# ACRS MEETING WITH THE U.S. NUCLEAR REGULATORY COMMISSION

November 7, 2008

# OVERVIEW

# Debris at Core Inlet

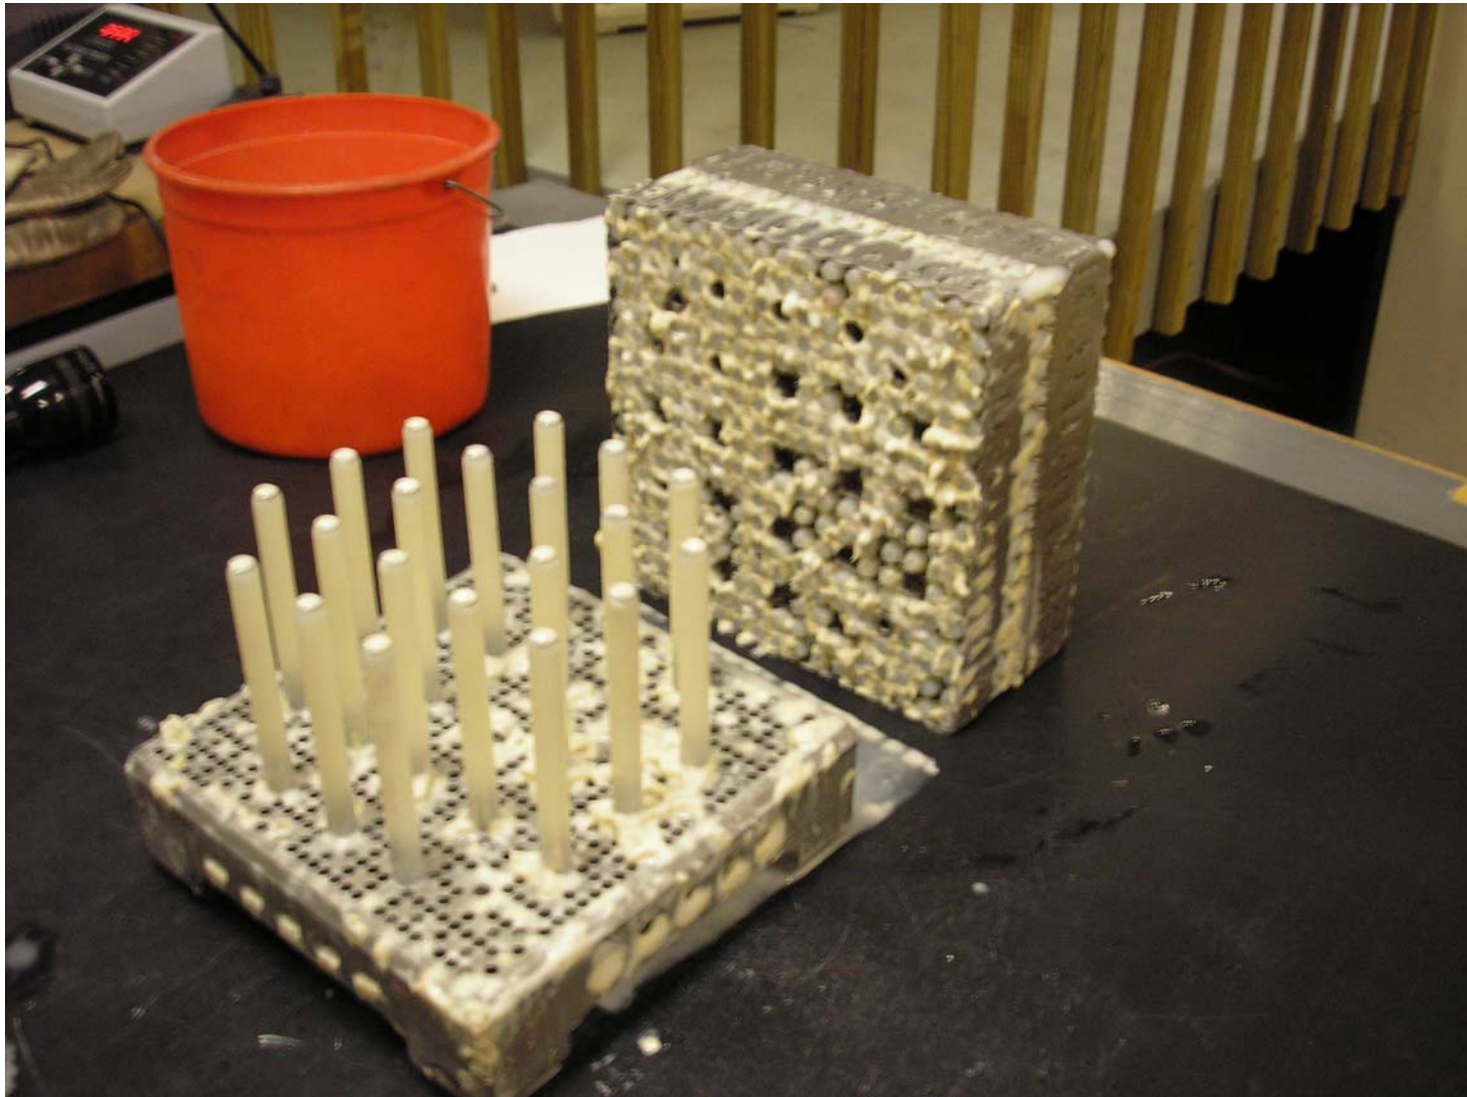
- Core is a second screen (in some sense)
- Ex-vessel effects downstream of the first screen are adequately accounted for
- PWROG investigation of in-vessel effects continuing. PWROG tests must encompass a sufficiently wide range of conditions, including cold-leg breaks

- Fiber length characteristics and loadings in tests must cover conditions representative of the first few flow passes through core
- If debris is uniformly distributed at core inlet, TRACE calculations for cold-leg breaks provide estimates of debris pressure losses that may cause overheating

# ACRS Views On Screen Head Loss Tests

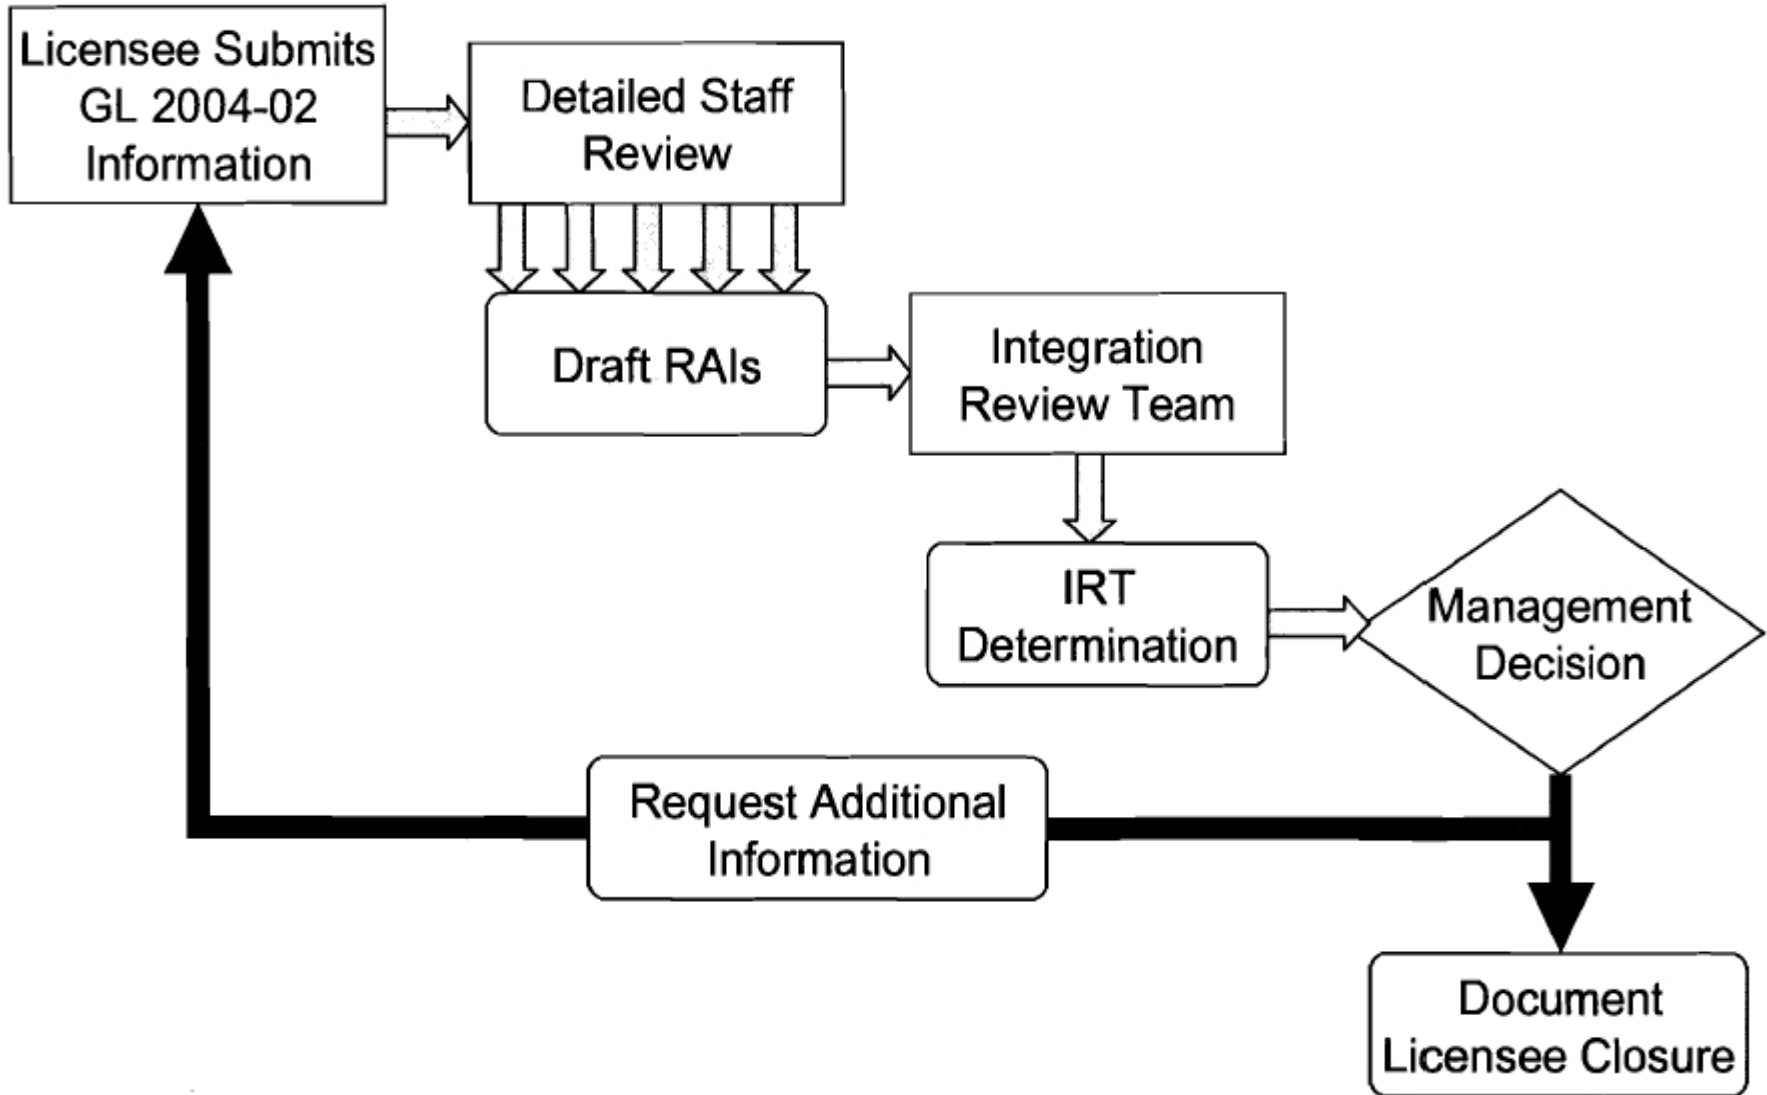
- Tests in which all fine-scale debris is entrained and carried to the screen may be extrapolated to plant scale
- Chemical effects are adequately accounted for
- Further development of test protocols and guidance is required for tests in which a substantial part of debris may settle upstream of the screen
